## REMARKS

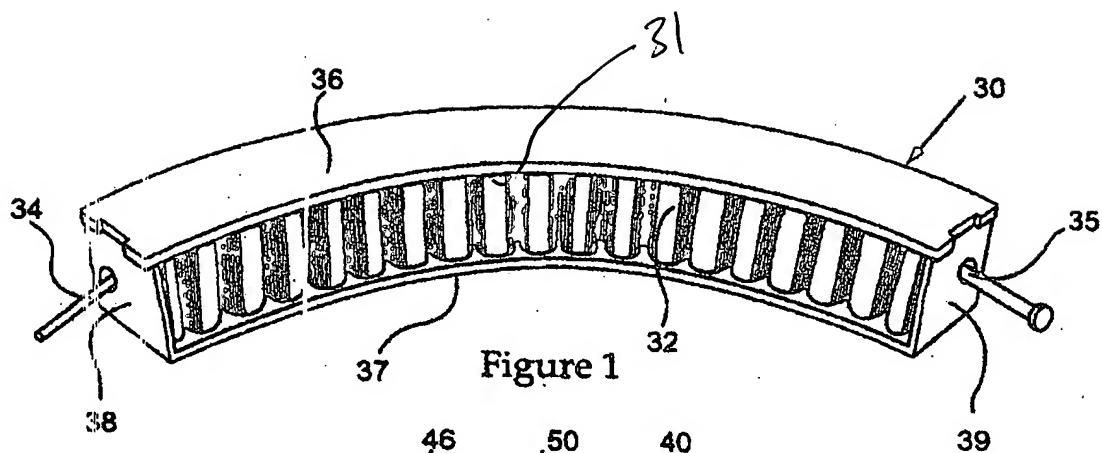
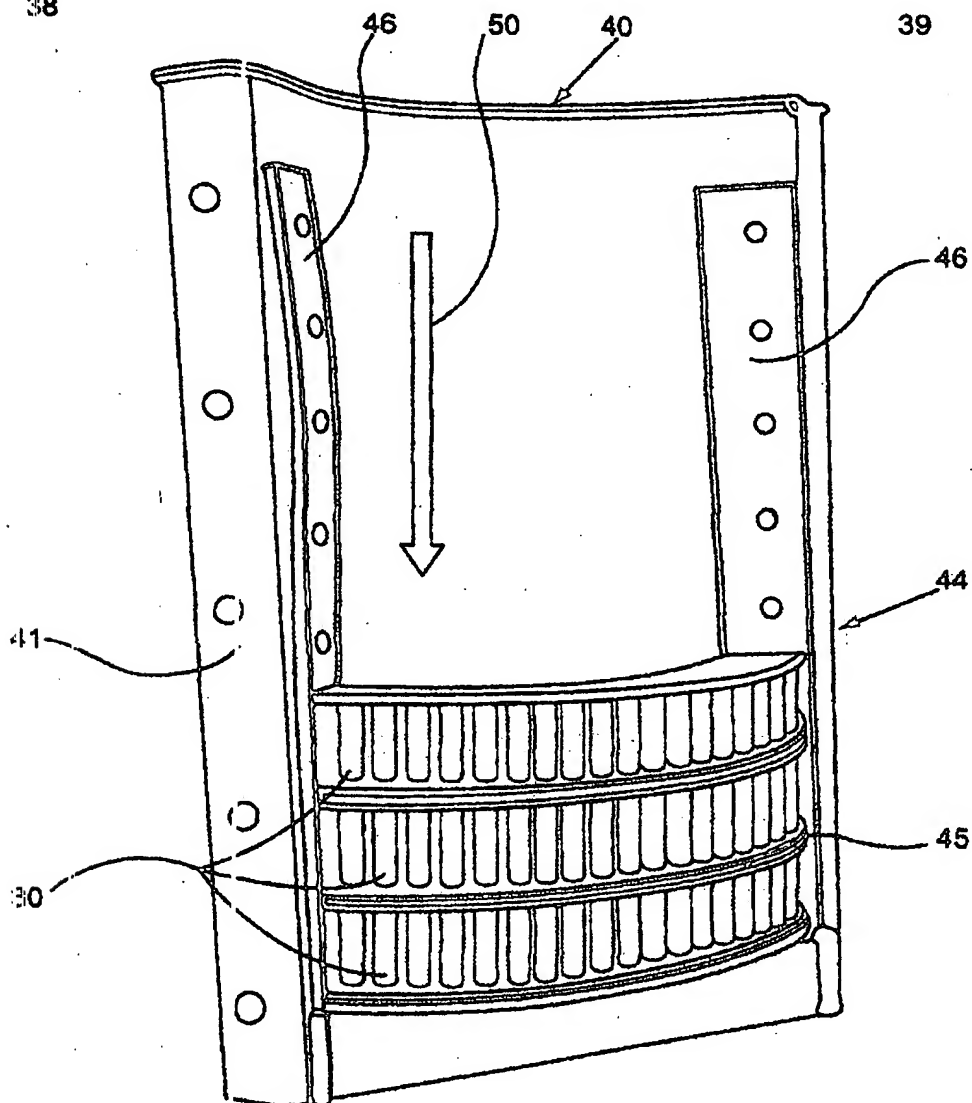
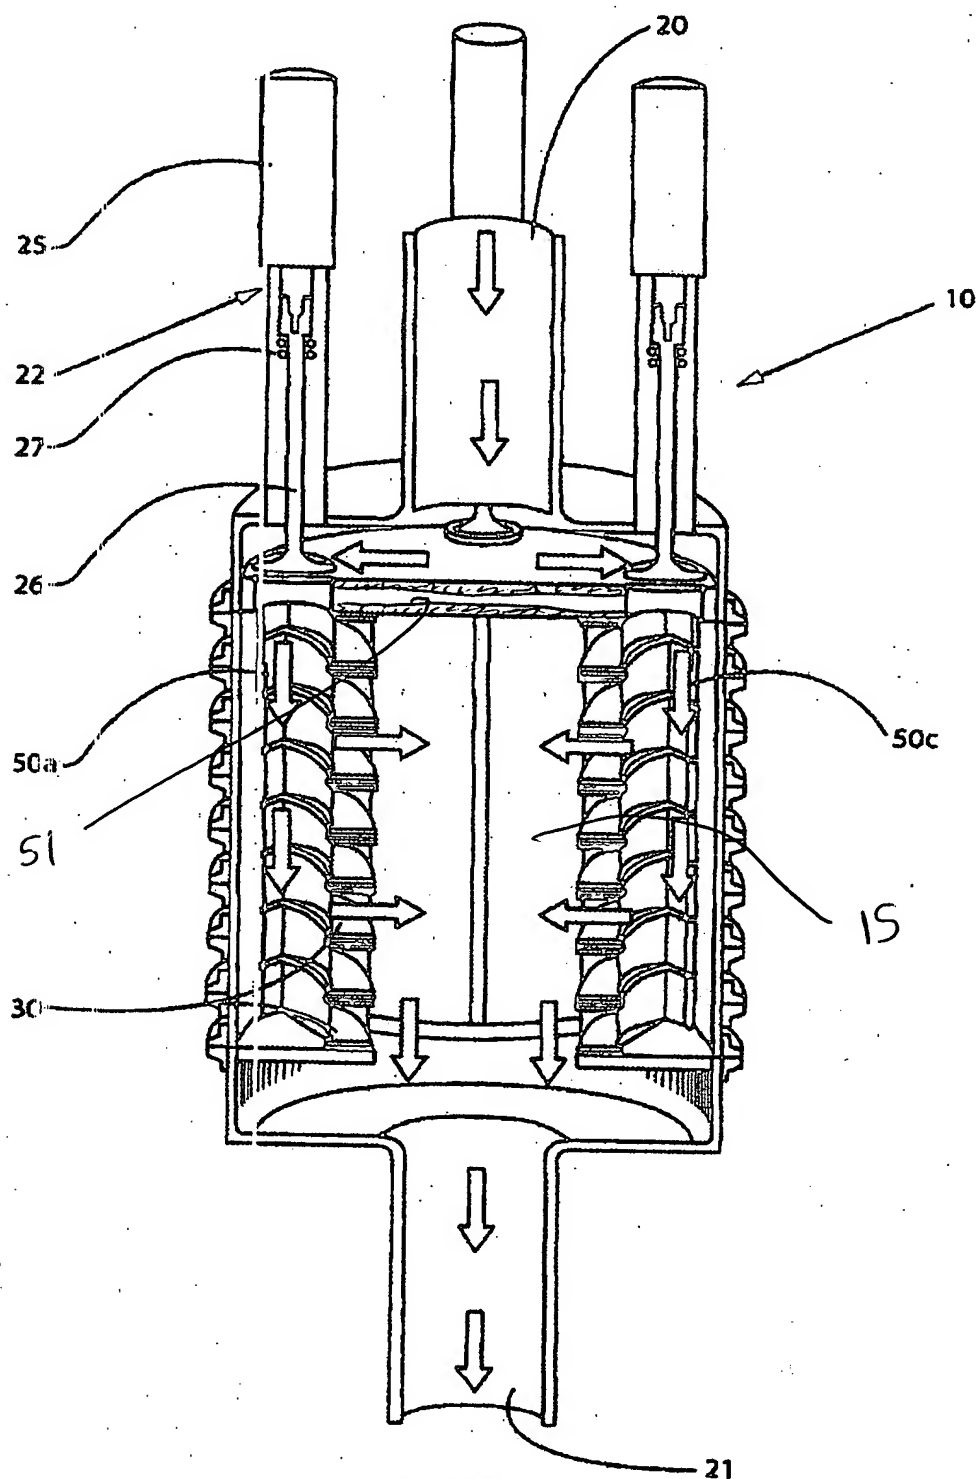
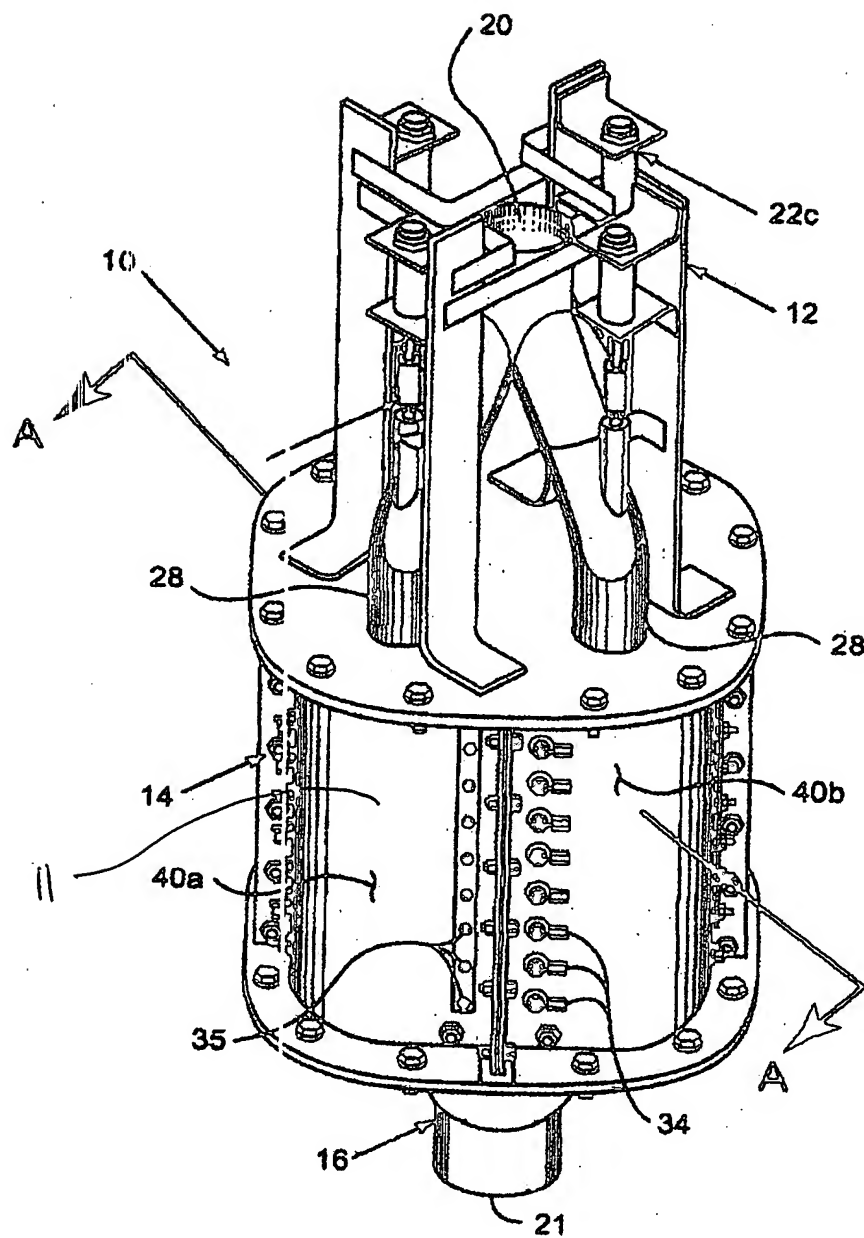
The drawings stand objected to because they failed to include the reference signs 11, 15, 31 and 51. In response, Applicants have attached hereto a proposed drawing correction that include those missing numbers shown in red. In addition, a set of replacement drawing sheets having the corrections incorporated therein is also included. Applicants respectfully request that the outstanding objection to the drawings be withdrawn, and that the substitute drawing sheets be entered.

Claims 8-14 stand rejected under 35 USC §112 for problems relating to the missing numeral 51 from the drawings as originally filed. In response, Applicants have included that numeral in the drawing correction which should avoid confusion over where Applicants' claimed cross flow passages are located adjacent the arrows in Figure 4. Therefore, Applicants respectfully request that the outstanding rejection of claims 8-14 under §112 be withdrawn.
